COMMITTEE OF ADJUSTMENT

NOTICE OF PUBLIC HEARING **Minor Variance**

APPLICATION NO.: HM/A-20:229

SUBJECT PROPERTY: Municipal address **412 Dundurn Street, Hamilton**

LEGEND:

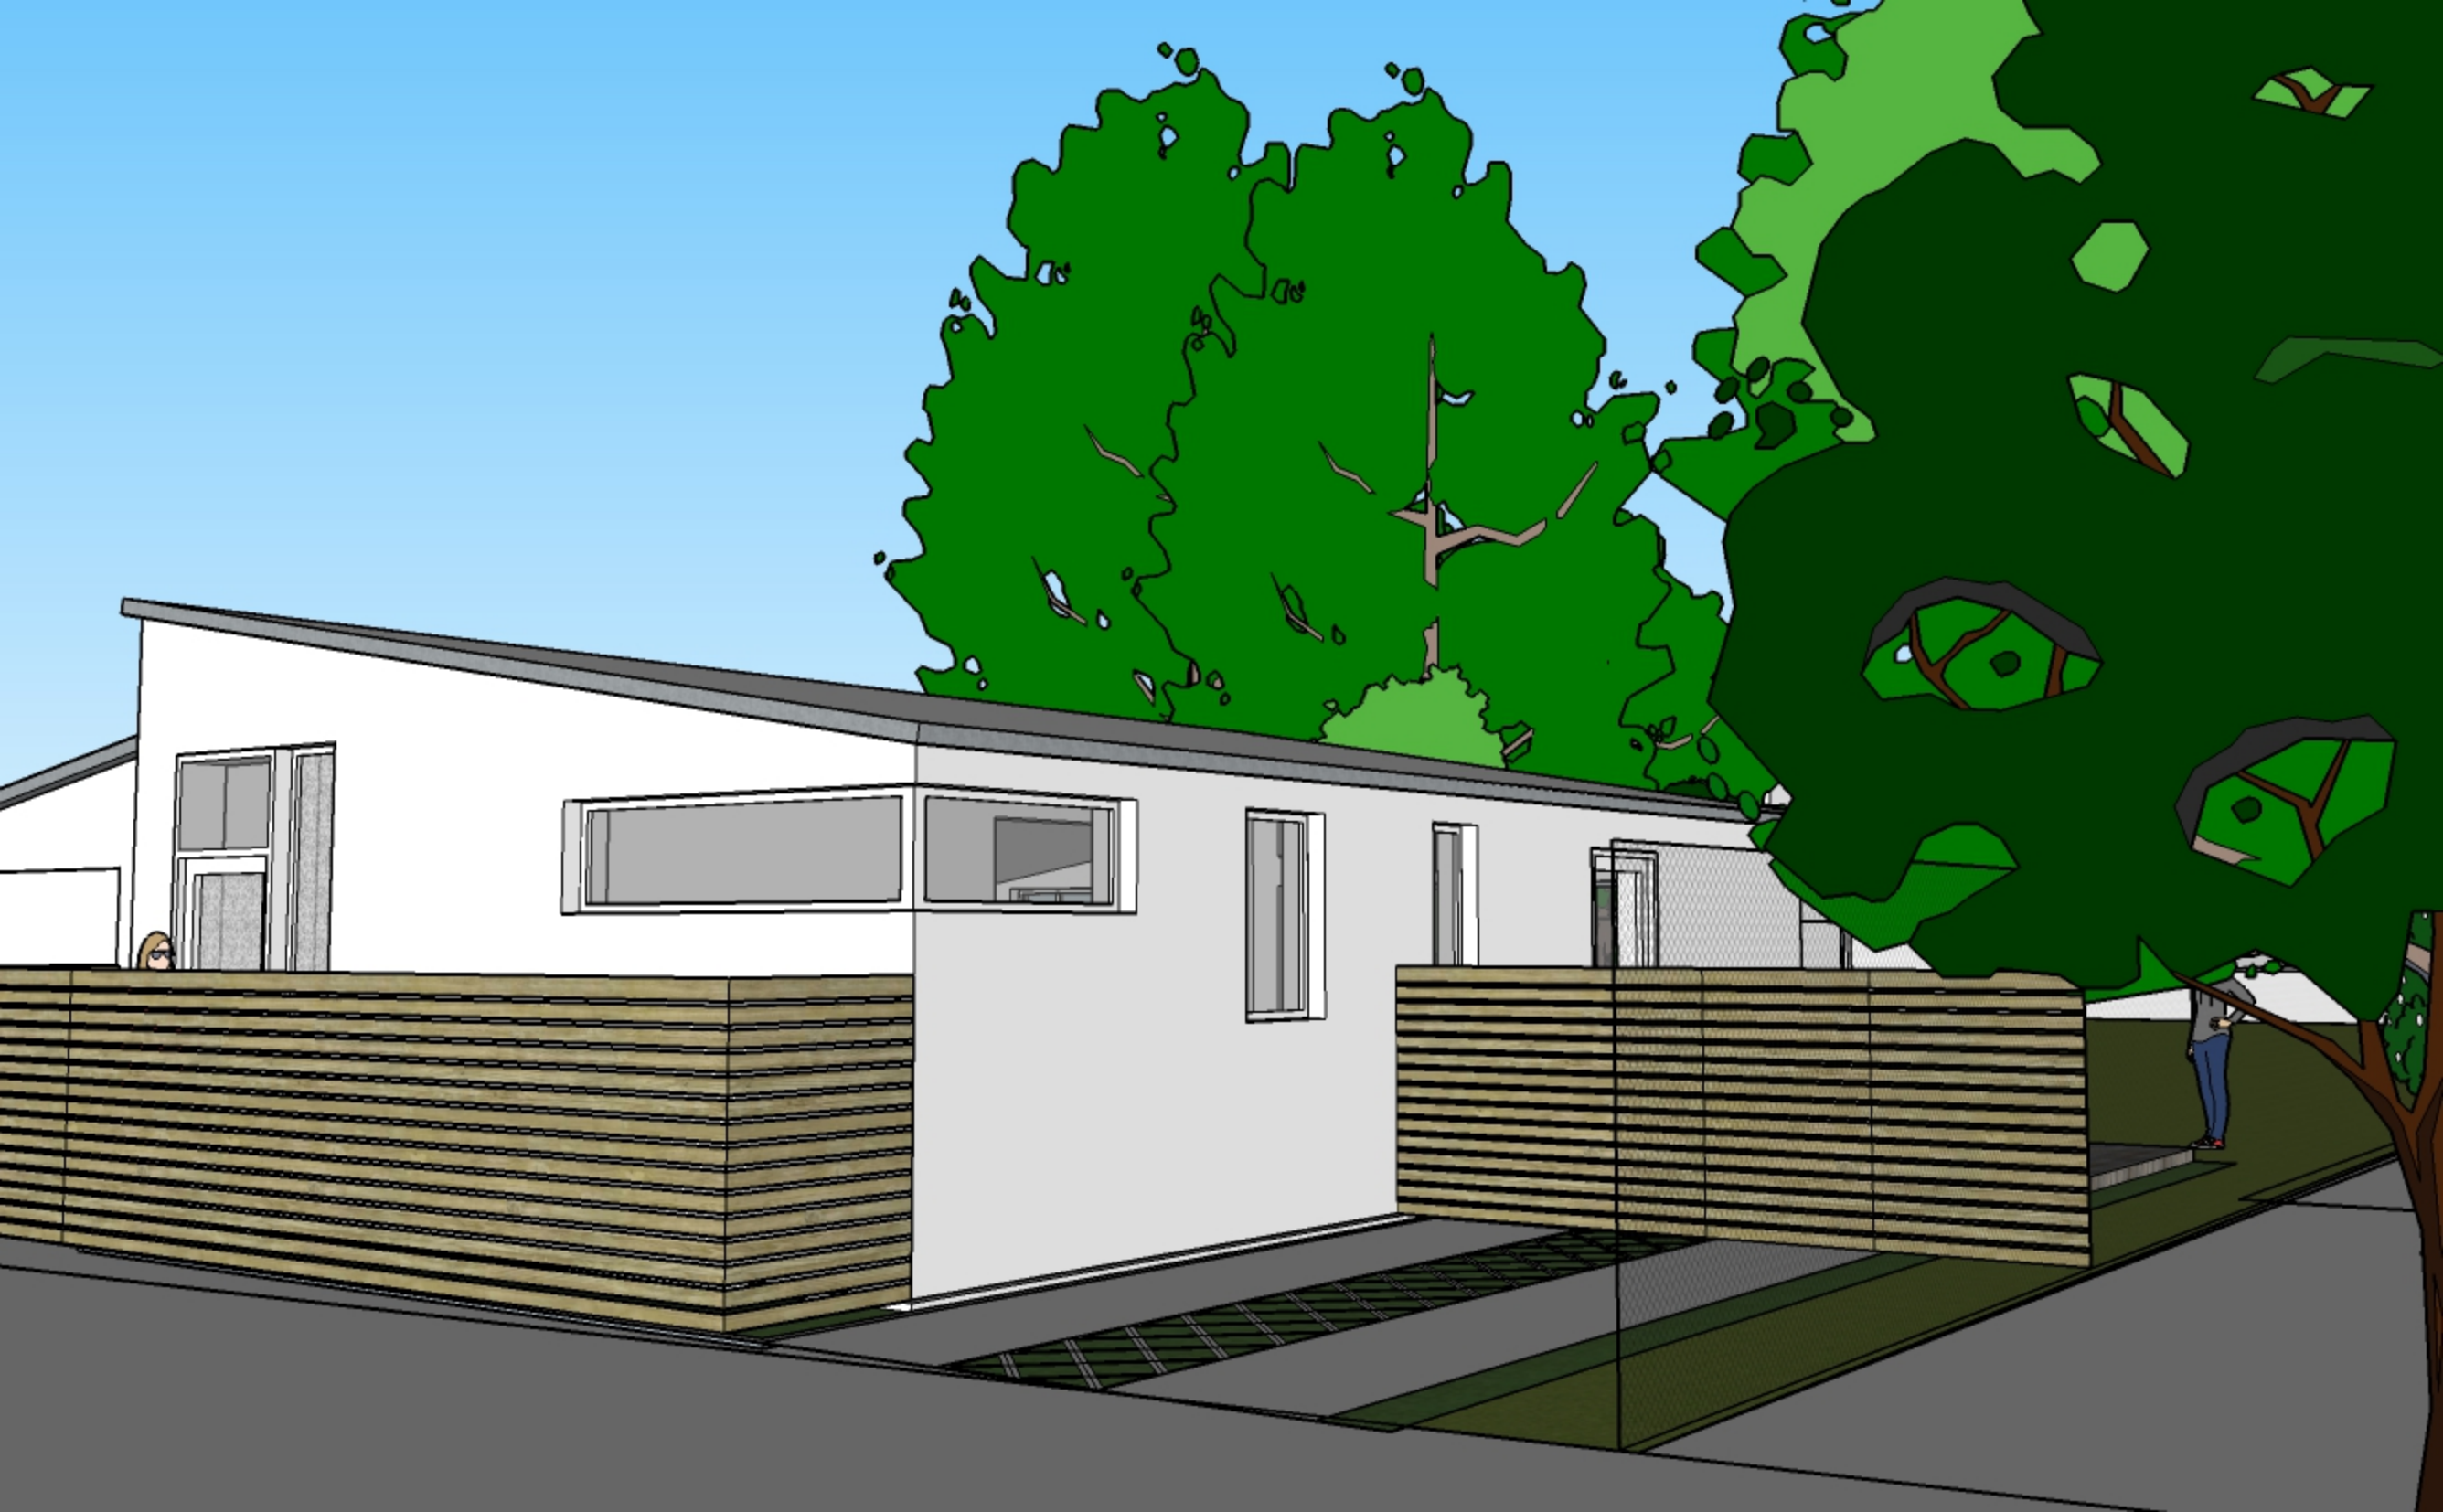
1. The minimum landscaped area to be provided in the rear yard was not indicated on the submitted site plan to confirm zoning compliance. Please note that an email provided by the applicant on August 3, 2021, confirmed that the landscaped area in the rear yard is to be greater than the required 12.0 square metres. Additional variance(s) may be required if compliance with Section 19(1)(xix) is not possible.

2. Please note that the distance the eaves/gutters encroach into a required yard was not indicated on the submitted site plan to confirm zoning compliance. Please note that an email provided by the applicant on August 3, 2021, confirmed that the eaves/gutters will not encroach more than the permitted 0.45 metres. Additional variance(s) may be required if compliance with Section 19(1)(1)(ii)(1) is not possible.

3. Please note that as per Section 19(1)(1)(ii)(6), a minimum setback from a Swale, Ditch or Drainage Management System measured from the upper most interior edge of the swale's slope of 1.0 metres shall be provided and maintained. Insufficient information has been provided to determine zoning compliance. Additional variances may be required if compliance with Section 19(1)(1)(ii)(6) is not possible.

4. Please note that as per Section 18(3)(vi)(e), a terrace may project into a required yard, if distant at least 0.5 metres from the nearest side lot line. The submitted site plan indicates a terrace is proposed in the southerly side yard abutting the secondary dwelling unit – detached, that extends to the southerly side lot line. Please note that an email provided by the applicant on August 3, 2021, confirmed that the terrace will be reduced in size and will be distant at least 0.5 metres from the southerly side lot line. Additional variance(s) may be required if compliance with Section 18(3)(vi)(e), is not possible

5. Please note that the specific dimensions of all proposed parking spaces and the width of the driveway(s) have not been indicated to confirm zoning compliance. Additional variance(s) may be required if compliance with Section 18A(7) and Section 18A(24)(a) is not possible.
